**From:** Waters, David [David.Waters@pgnmail.com]  
**Sent:** Monday, July 02, 2012 4:10 PM  
**To:** Habib, Donald  
**Subject:** Letter 108 Draft RAI Response  
**Attachments:** NRC Letter 108 RAI L-0998 Response - Draft 07-02-12\_Part3.pdf

**Levy Nuclear Plant Units 1 and 2  
COL Application  
Part 2, Final Safety Analysis Report**

Figure 2.5.2-357 Comparison of PBSRS based on updated EPRI-SOG and CEUS SSC models

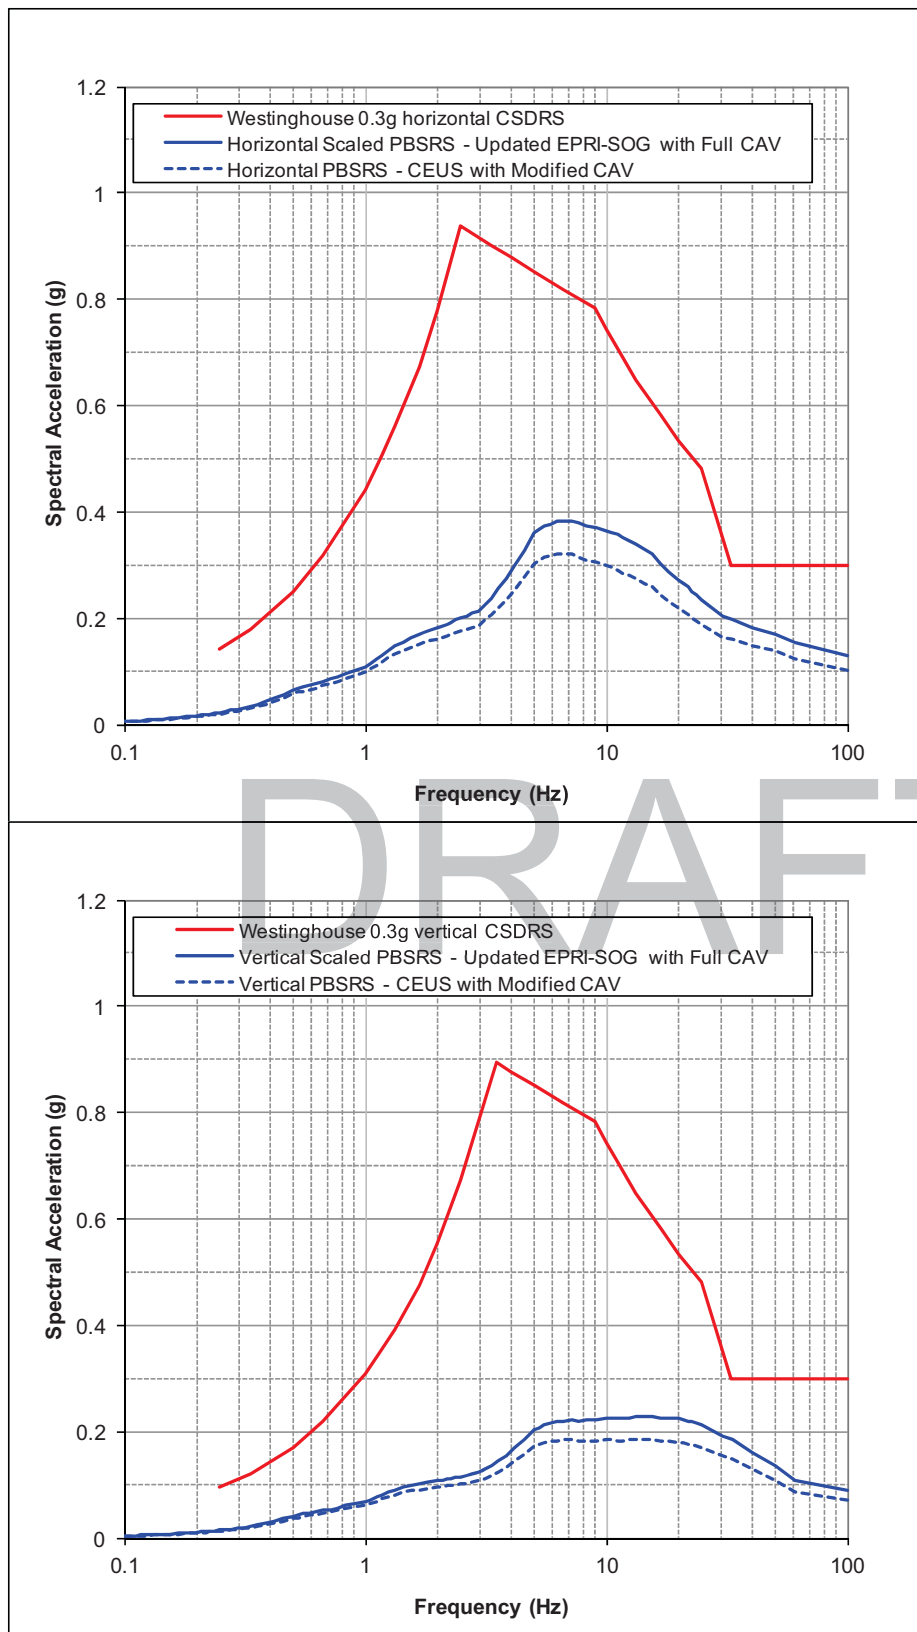
adjacent AB, TB, and RB, earthquake induced cyclic stresses in the soil column were based on ground motions consistent with the finished grade scaled PBSRS. As shown in Figure 2.5.2-357, the CEUS SSC PBSRS is enveloped by the update EPRI SOG scaled PBSRS. Thus, the liquefaction evaluations based on the updated EPRI SOG LNP ground motions bound those from the CEUS SSC ground motions.

As shown in [Figure 2.5.2-357](#), the CEUS SSC PBSRS is enveloped by the updated EPRI SOG scaled PBSRS used for site specific displacement of the Annex Building, Turbine Building, and the Radwaste Building as described in [Subsections 3.7.2.8.1](#), [3.7.2.8.2](#), and [3.7.2.8.3](#). Thus the conclusions in these subsections of no seismic interaction between the Annex Building, Turbine Building, and Radwaste Building and the NI is valid for the LNP site ground motions based on the CEUS SSC model.

**Figure 2.5.2-358:** Comparison of Reactor Building FIRS based on updated EPRI-SOG and CEUS SSC models

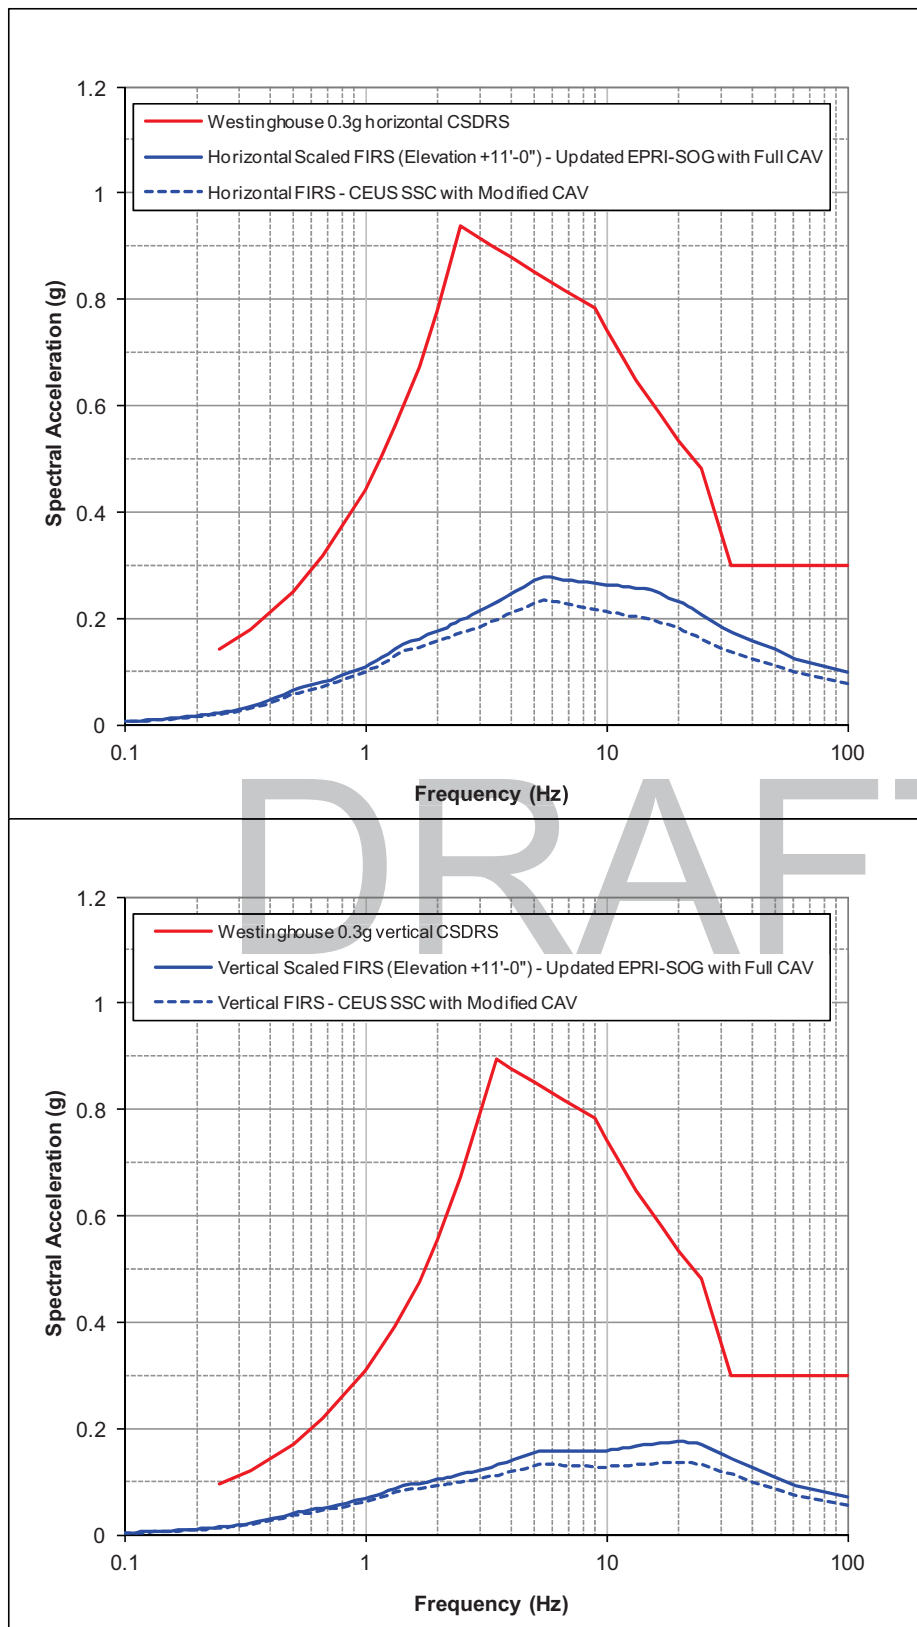
As shown in [Figure 2.5.2-358](#), the CEUS SSC horizontal and vertical FIRS is enveloped by the updated EPRI SOG scaled horizontal and vertical FIRS used for site specific soil structure interaction analysis described in [Subsection 3.7.2.4.1](#). Thus, the conclusions of the soil structure analysis presented in [Subsections 3.7.2.4.1.5](#) and [3.7.2.4.1.6](#) are valid for the LNP site ground motions based on the CEUS SSC model.

Figure 3.7-228

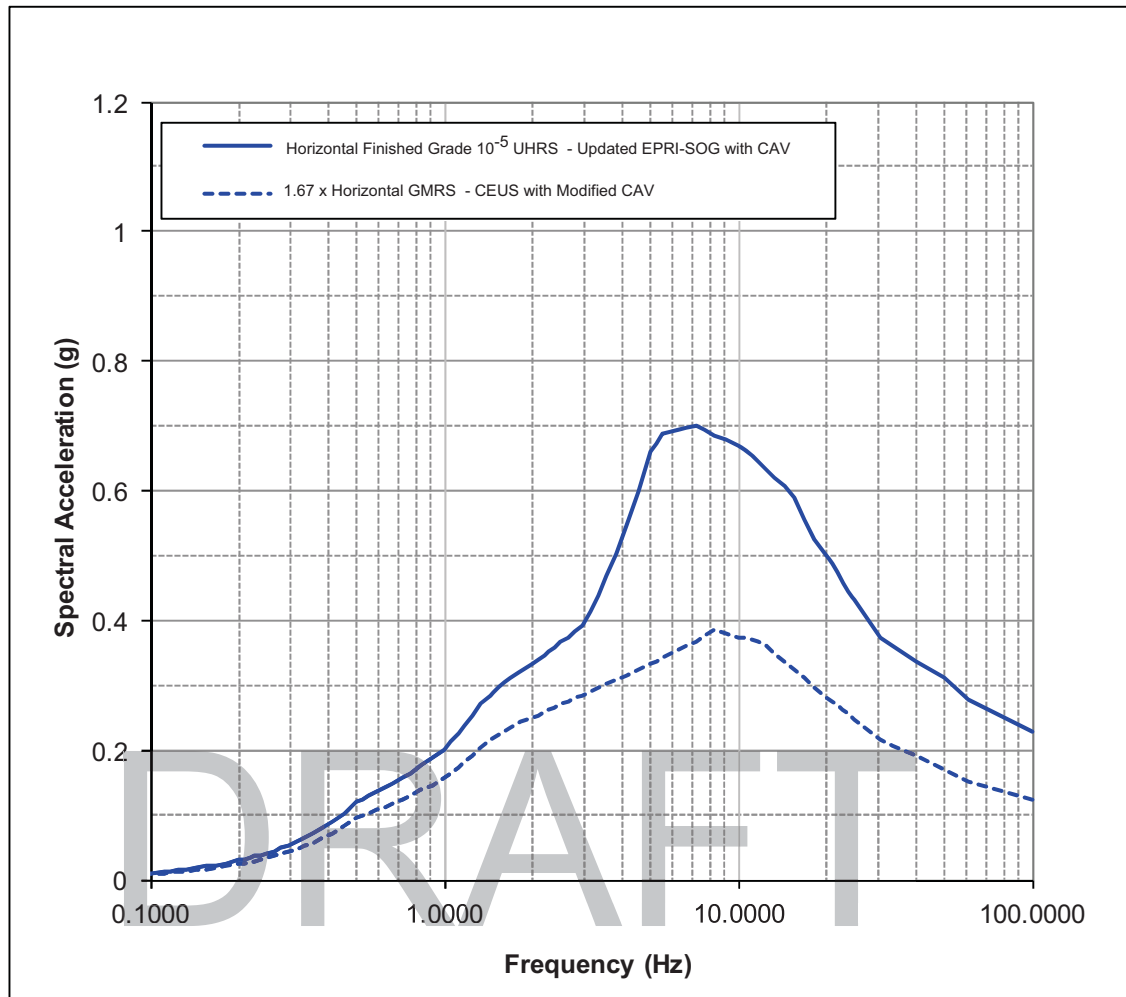
To evaluate the HCLPF liquefaction potential of soils under the adjacent AB, TB, and RB, earthquake induced cyclic stresses in the soil column based on ground motions consistent with the updated EPRI SOG finished grade  $10^{-5}$  UHRS were used. As shown in Figures 3.7-228 and 3.7-229,  $1.67^*GMRS$  and  $1.67^*PBSRS$  developed using the CEUS SSC methodology and modified CAV filter are enveloped by the updated EPRI SOG finished grade  $10^{-5}$  UHRS. Thus, HCLPF capacity for no liquefaction potential of soil under the AB, TB, and RB exceeds the  $1.67^*GMRS$  goal for the plant level HCLPF for the CEUS SSC ground motions.

To evaluate the HCLPF capacity for no seismic interaction between the AB, TB, and RB foundation mats and the NI, the relative displacement between the NI and the AB, TB, and RB foundations was computed based on the updated EPRI SOG  $10^{-5}$  UHRS. As shown in Figures 3.7-228 and 3.7-229, 1.67\*GMRS and 1.67\*PBSRS developed using the CEUS SSC methodology and modified CAV filter are enveloped by the updated EPRI SOG  $10^{-5}$  UHRS. Thus, HCLPF capacity for no seismic interaction between the AB, TB, and RB foundation mats and the NI exceeds the 1.67\*GMRS goal for the plant level HCLPF for the CEUS SSC ground motions.
